**LEXINGTON-FAYETTE URBAN COUNTY  
 GOVERNMENT CONTRACT CHANGE ORDER**  
 Page 1 of 2

Date:	<b>April 19, 2016</b>
Project:	Idle Hour Park Improvements
Location:	Lexington
Contract No.	242-2015
Original Contract Amt.	\$479,230.00
Cumulative Amount of Previous Change Orders	\$159,497.35
Percent Change - Previous Change Orders	33.28%
Total Contract Amount Prior to this Change Order	\$638,727.35
Change Order No.	<b>2</b>

PROJECT: Idle Hour Park Improvements

SUBJECT: Request Council Authorization to Execute Change Order #2 with Bluegrass Contracting Corporation in an amount **Not To Exceed** \$60,000.00 for the Idle Hour Park Improvements Project, Contract #242-2015

Figure 1: Approximate Area of Observations

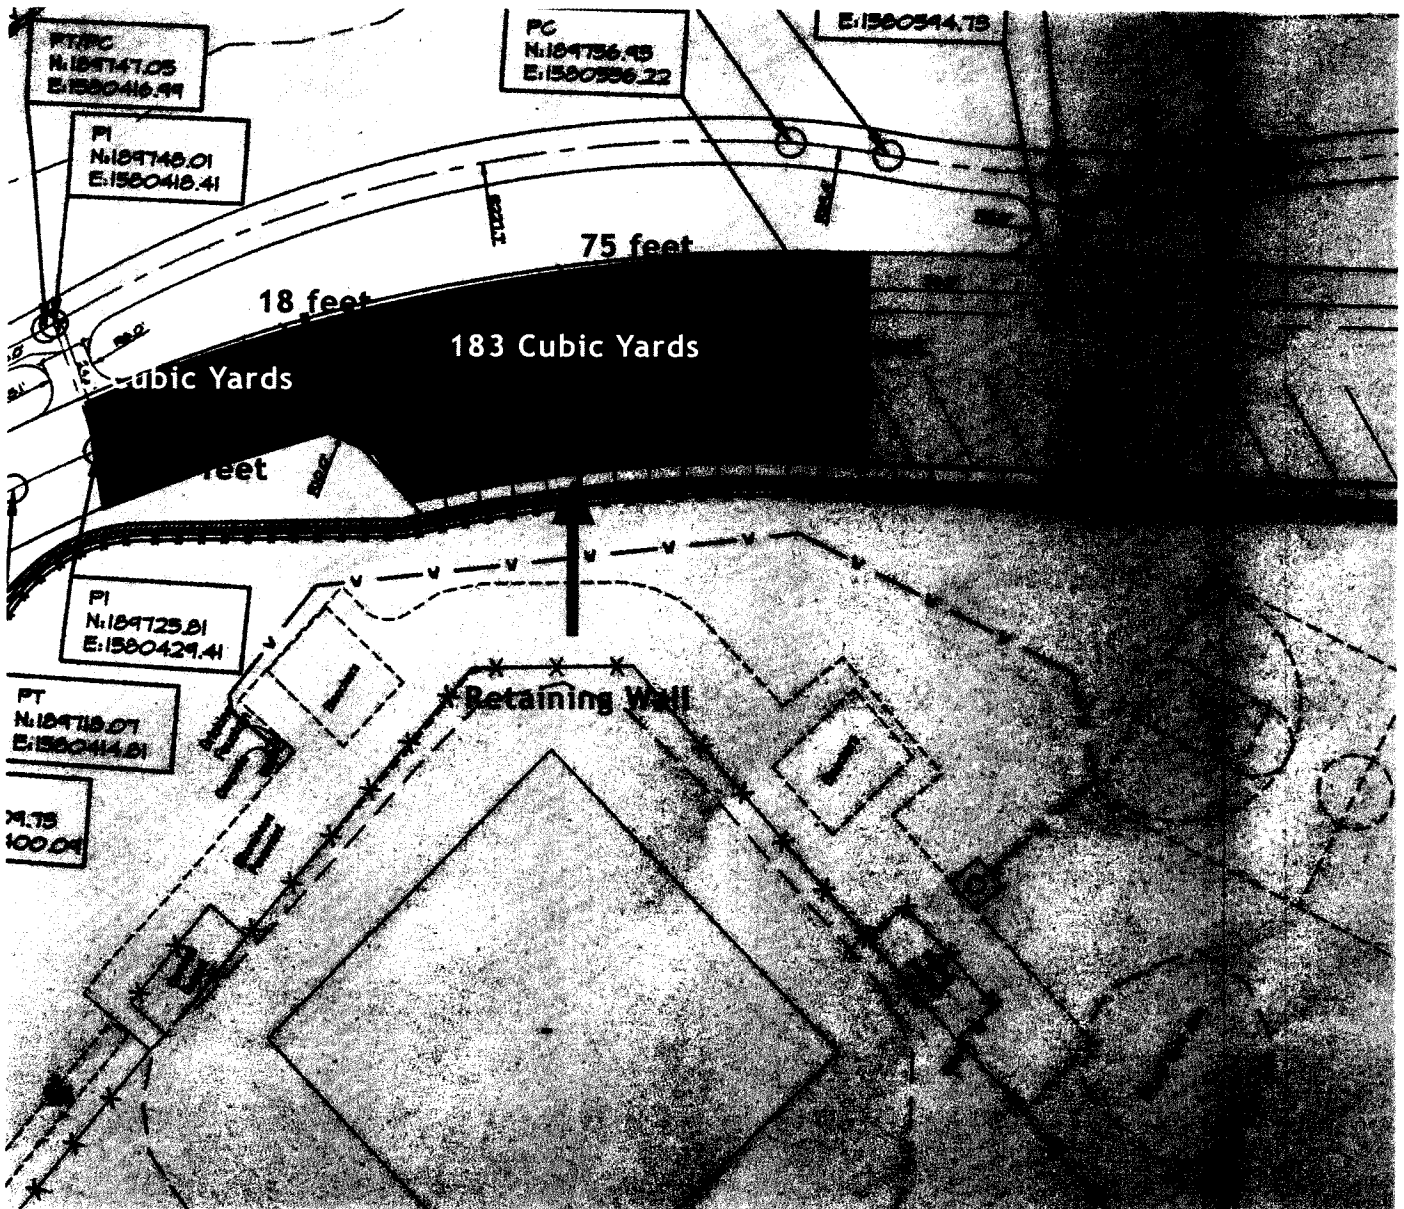
Description of Change: Provide pricing to remediate existing subgrade conditions uncovered at new parking lot area. NOTE- extend remediation 5' to each side of parking area beyond dimensions indicated on attached to avoid failure at pavement edges.

Per attached, provide pricing to overexcavate 24" below proposed pavement section, install Tensar BS 1200 or similar approved product, backfill with #2 stone to design subgrade. Utilize Contract Unit Prices for applicable work.

The proof roll revealed soft pumping material throughout the roadway beginning at the end of the existing asphalt roadway to 130 linear feet. The pumping was evident throughout the full width of the proposed roadway and through the proposed Keystone retaining wall area. The remaining portion of the proposed roadway revealed minimum deflection.

The soft pumping area measured to be 75 feet by 33 feet and 55 feet by 18 feet. A test pit was excavated to determine the depth of the soft material. The test pit was advanced down to a depth of two feet with no bearable material encountered through this point. An estimated 256 cubic yards of material was measured to be excavated out, as shown Figure 1.

Based on our reconnaissance of the site and our understanding of the project we believe the soft soils encountered will not support the proposed construction and will need to be stabilized to facilitate the construction above the subgrade. Such stabilization can be achieved by undercutting the soft materials down two feet, lining the soft area with a reinforced geotextile fabric and backfilling with a #2 stone like aggregate back up to the designed subgrade elevation. Once the stabilization has occurred the area should be evaluated by proof rolling to verify stability prior to placement of the pavement section or Keystone wall.

Below is our pricing to perform the undercut of unsuitable material for the roadway and retaining wall as detailed in the CSI report dated April 6<sup>th</sup>, 2016. I have adjusted the quantities based on CSI recommendation to undercut five (5) feet outside the edge of the roadway and include undercut under the retaining wall.

408 CY Unsuitable Soil Removal @ \$26 CY = \$10,608.00  
530 TN #2 Stone @ \$28/TN = \$14,840.00  
612 SY BX1200 @ \$3/SY = \$1,836.00
